Delta-Mendota Canal/ California Aqueduct Intertie

Final Environmental Impact Statement

Volume III: Responses to Comments

Volume III— Responses to Comments on the DEIS

Proposed Alternative Locations for the Intertie Project

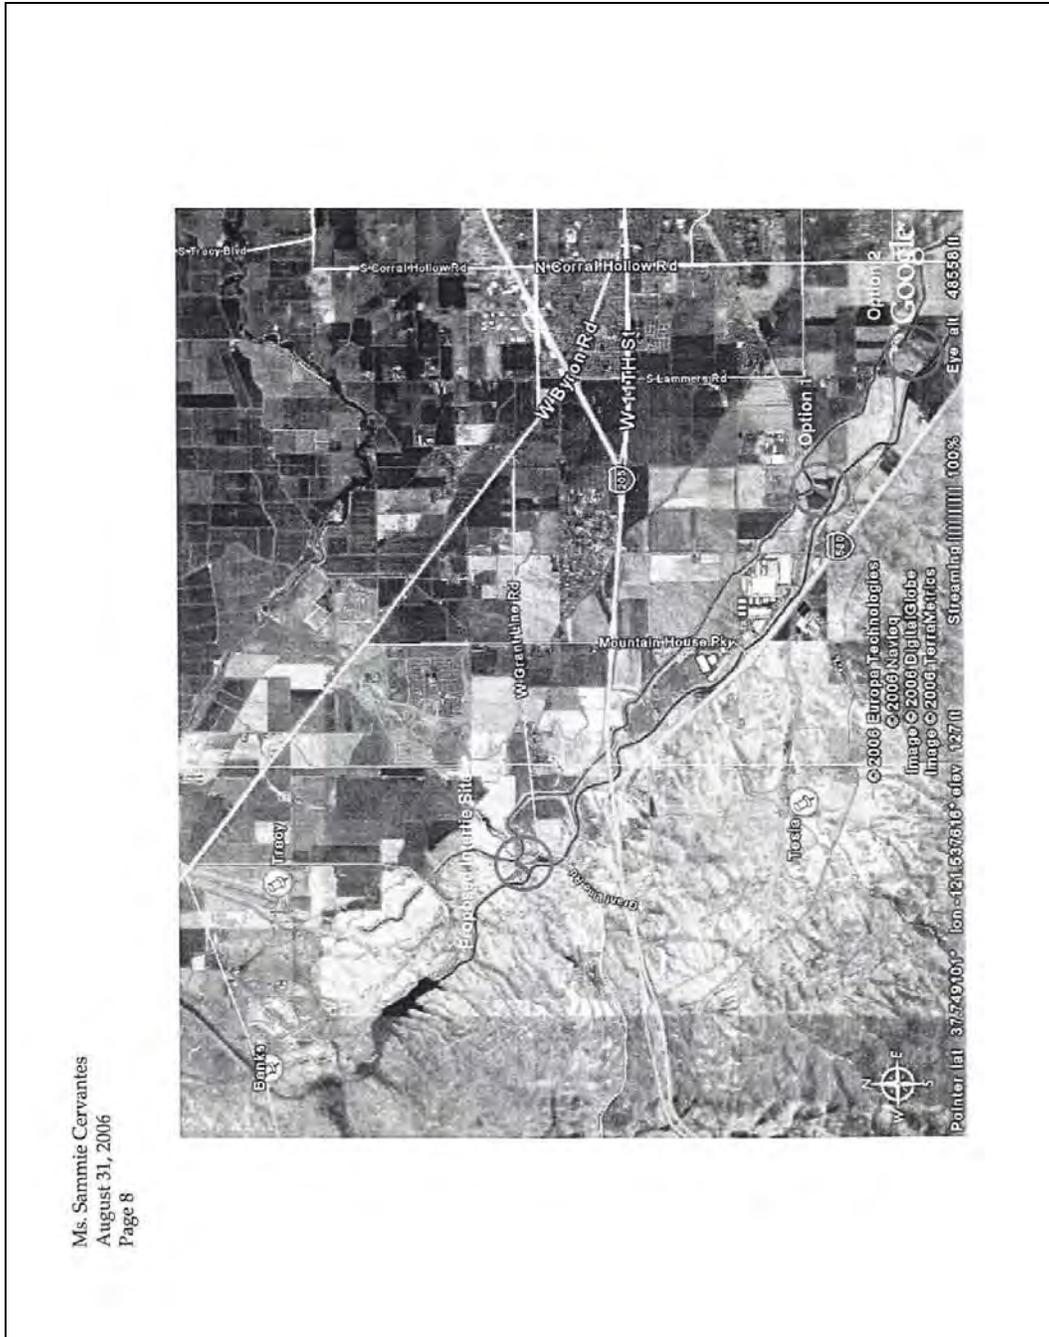
We request that Reclamation consider the two alternative locations for the Intertie Project shown on Figures 1 through 4. COTP Engineering staff has identified two locations outside of the COTP right of way where the proximity of the Delta-Mendota Canal and the California Aqueduct is comparable to their proximity Reclamation's proposed location..
